**Town of Millbury, MA  
Proposed Bridge Replacement  
Wheelock Avenue over Dorothy Pond  
Bridge No. M-22-022 (CPC)  
Addendum No. 1**

To be considered as part of the contract drawings and specifications for the Proposed Bridge Replacement – Wheelock Avenue over Dorothy Pond – Bridge No. M-02-022 (CPC). Bidders are advised that this Addendum must be acknowledged in the appropriate space provided on the Form for General Bid.

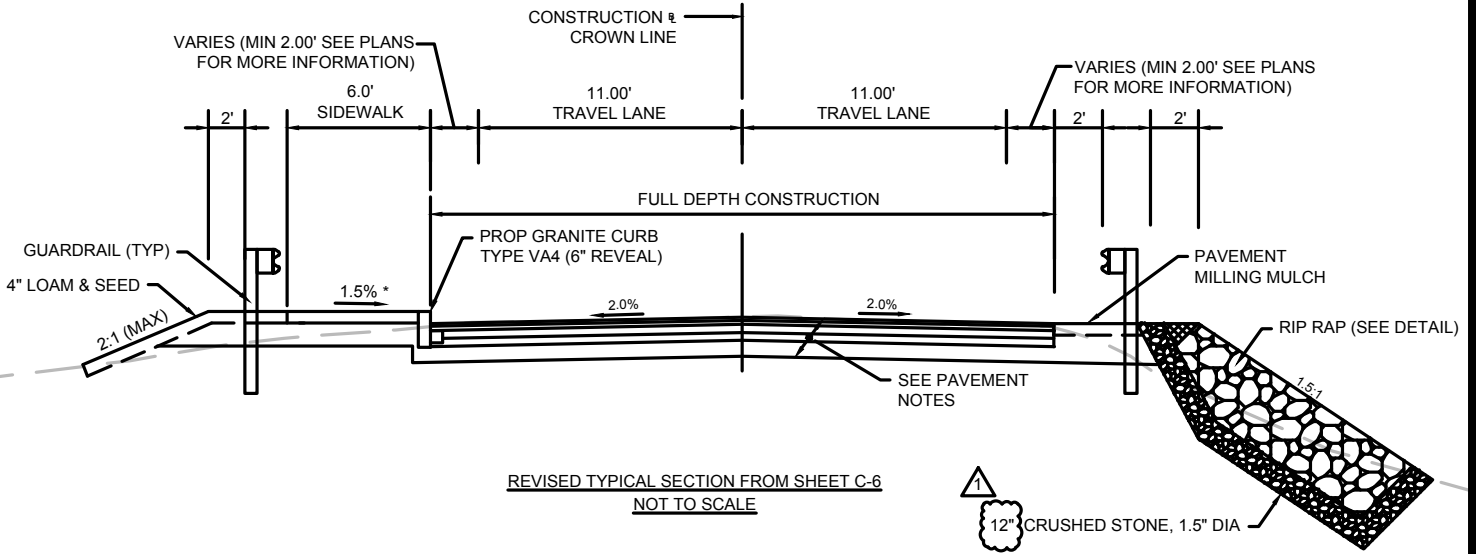
**Sheet C-6 – CONSTRUCTION DETAILS (2 of 3) - Detail: TYPICAL SECTION – WHEELLOCK AVENUE**

- 1. The thickness of the crushed stone is revised to be 12” on sheet C-6. See Sketch SK-1 in Attachment 1 of this addendum.

- Q3. The detail for Slope Rip Rap on drawing C-7 shows 12" of crushed stone below the Rip Rap. The typical section – Wheelock Ave on drawing C-6 shows it as 6" thick. Can we assume that the 12" thickness from the detail is correct?
- A3. The thickness of the crushed stone is revised to be 12" on sheet C-6, so it matches Sheet C-7. See above revision under DRAWINGS/SHEET C-6, and see Sketch SK-1 in Attachment 1 of this addendum.
